# Ordinary Council

**Subject: MAYORAL MINUTE - INDEPENDENT REPORT ON THE PORT  
MACQUARIE SOUTHERN BREAKWALL BY ANGUS GORDON**

## Management of South Port Macquarie Breakwater

Coastal Zone Management and Planning was engaged by Damian King, on behalf of the “Save our Breakwall” campaign, to provide an independent review of the current state of the Southern breakwater at Port Macquarie and the recent reports regarding condition, repair and upgrading.

APPENDIX A - MHL 1993 Asset Appraisal and repair recommendations for Southern Wall  
(this summary is supported by 10 pages of detail)

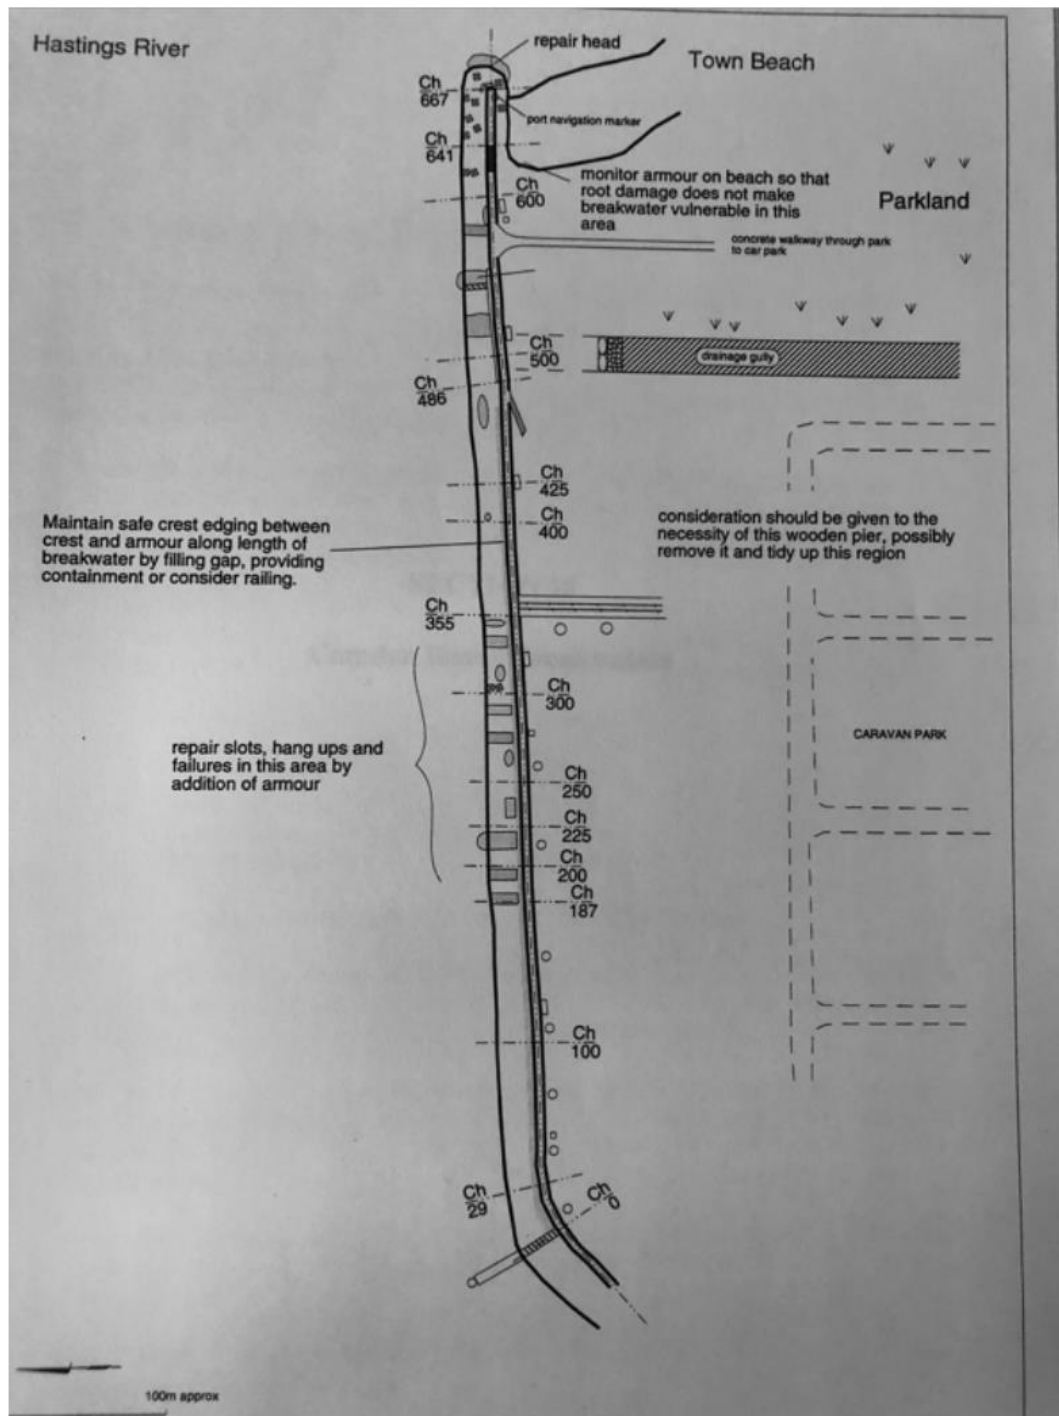
It is important to note that in the MHL appraisal report the difference between the areas identified in the field inspection as against the relatively fewer areas considered to need attention particularly between chainages 187 and 365 and from 500 to the head.
